# SCHWEIZER SERVICE NOTICE

NOTICE NO. N-163

**SUBJECT:** PN269A6050 SERIES AND PN 369A1800-3 TAIL ROTOR PITCH CONTROL ASSEMBLY - SEATING OF BEARING INNER RACE; TORQUE INCREASE FOR PN 269A6258 LOCKNUT

**MODELS AFFECTED:** All Model 269A, TH-55A, 269A-1 and 269B Helicopters  
Model 269C Helicopter Serial No. 0004 thru 0789

Figure 1. Tail rotor pitch control assembly - seating of bearing and increased torque for locknut

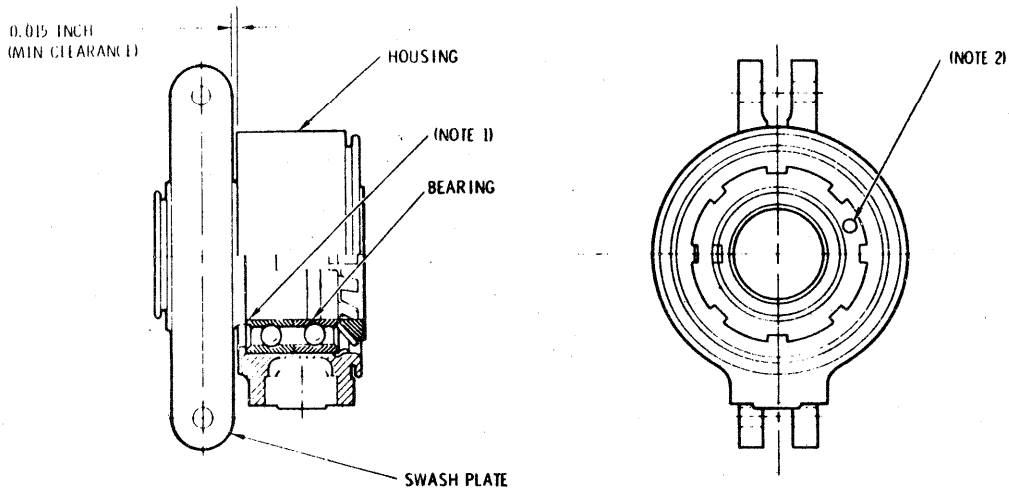
d. Place housing and swashplate assembly on arbor press bed with swashplate end down. Apply 2000 pounds of pressure to press inner race of bearing firmly in contact with shoulder of swashplate. Use suitable tube or sleeve to press INNER race of bearing only. Remove assembly from arbor press.

e. Install new 269A6051 or 369A1816 tang washer; reinstall locknut and torque locknut to 400 to 450 inch-pounds. Use wrench adapter and torque wrench, while assembly is held in holding block, to tighten locknut.

f. Check for sufficient clearance (0.015 inch minimum) between swashplate and housing ( see Figure 1).

i. Paint a 0.12 to 0.18 inch white dot on locknut, as shown in Figure 1, to denote reseating of bearing and locknut torqued to 400 to 450 inch-pounds.

- NOTES:  
1. INNER RACE FIRMLY SEATED AGAINST SHOULDER OF SWASH PLATE  
2. AFTER TORQUE, COLOR CODE WITH WHITE DOT (0.12 - 0.18 IN. DIA)
